Please see below for addressing the comments that were provide regarding the landscape plan in an email to Ms. Miller dated June 24, 2026:

Planning & Zoning Review Responses

PROJECT: **Permit No. SUBFY2026-0002**

Siberian Elm Subdivision (43rd Street Townhomes Subdivision)

L1.0

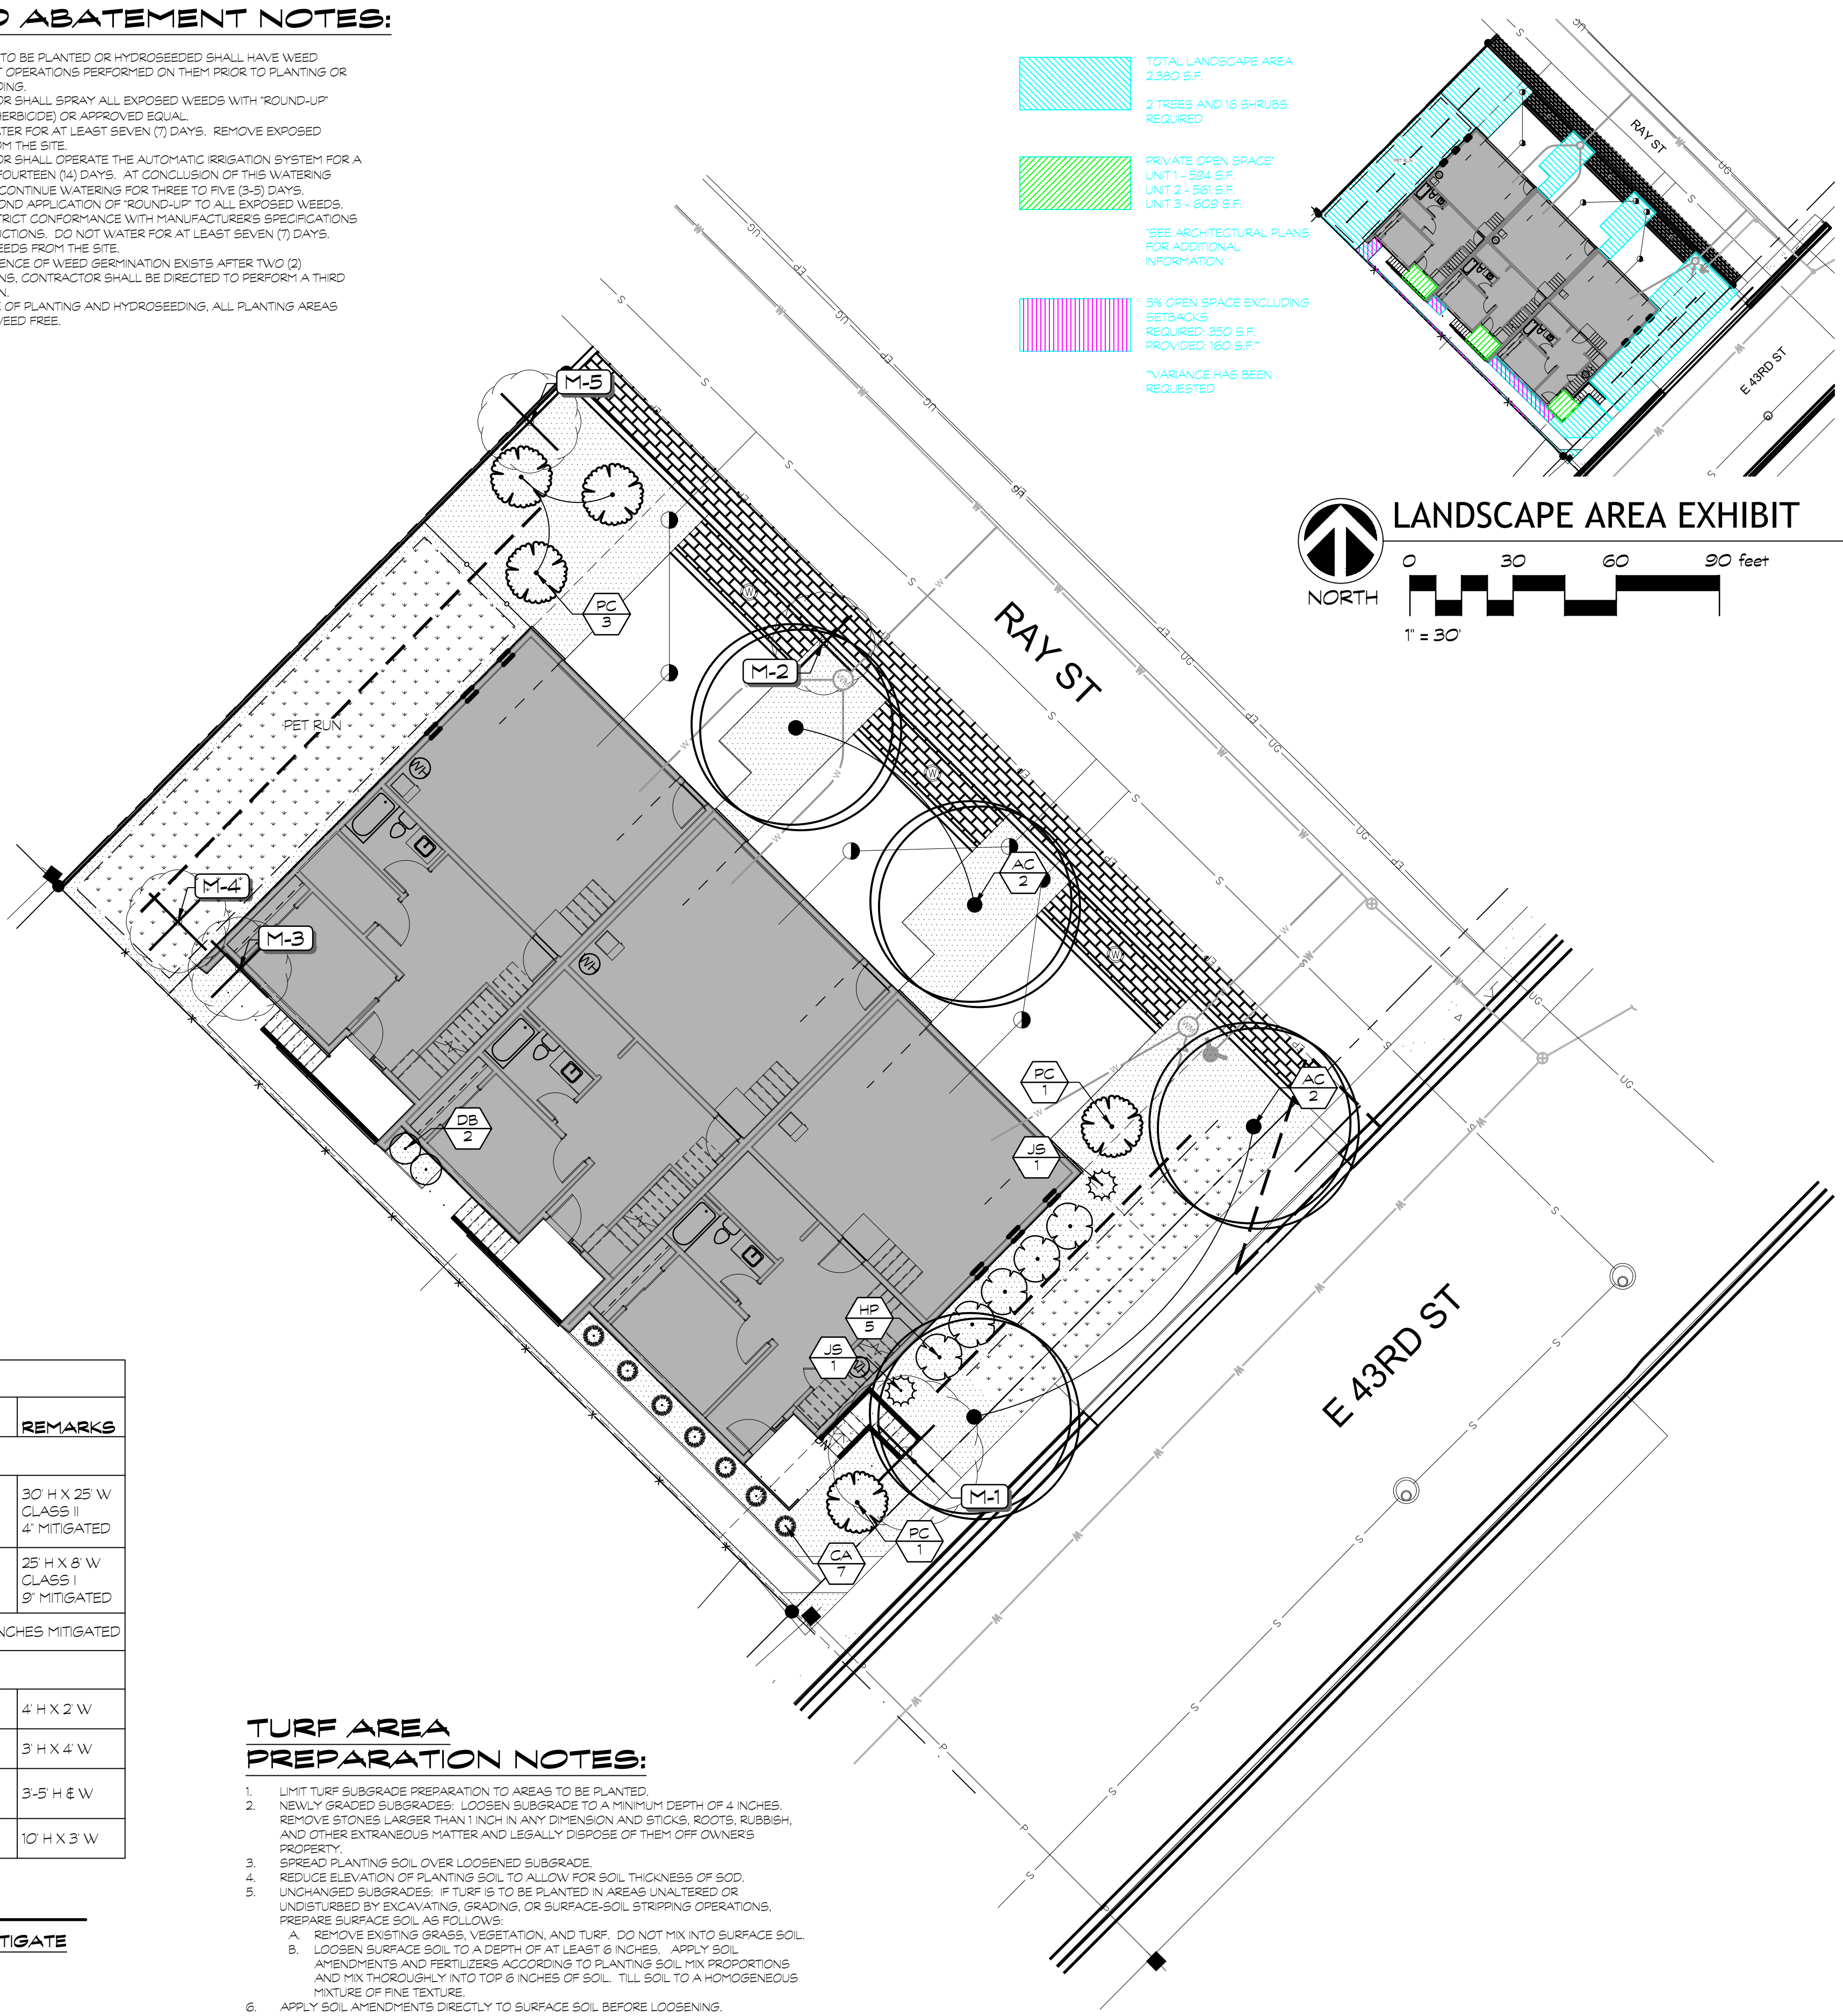
1. A landscape exhibit identifying the location of the calculated landscape area has not been provided.
 - A landscape exhibit has been included on sheet L 1.0 to include total open space, private open space, and 5% open space. Please note that additional private open space on the second and third floors of each unit has been added to the total square footage shown on sheet L1.0. Please note that a variance is being requested for the 5% required landscape outside of any setbacks.

3. The landscape plan identifies 11 caliper inches requiring mitigation; per the arborist report, this should be 13 caliper inches.
 - Mitigation on sheet L1.0 has been updated to reflect the arborist report.

4. I believe tree M102 on the landscape plan corresponds to Tree #4 in the arborist report (a 6" juniper). Please confirm.
 - Mitigation on sheet L1.0 has been updated to reflect the arborist report.

5. Tree #1 in the arborist report is identified as an apricot tree in poor health, but the landscape plan identifies it as a Malus tree in fair condition. Please clarify, as this appears to be an error.

- Mitigation on sheet L1.0 has been updated to reflect the arborist report.
6. Tree #3 from the arborist report (identified as fair condition) does not appear to be identified on the landscape plan.
- Mitigation on sheet L1.0 has been updated to reflect the arborist report.
7. Per GCC §8-4B-3, what is being proposed in place of the Class C amenity previously identified, given that it has not been demonstrated to meet code requirements? Additionally, please confirm whether the other previously identified amenities have been corrected and properly identified?
- An enclosed pet run is being proposed on the northwest side of the development with a gate facing Ray Street.
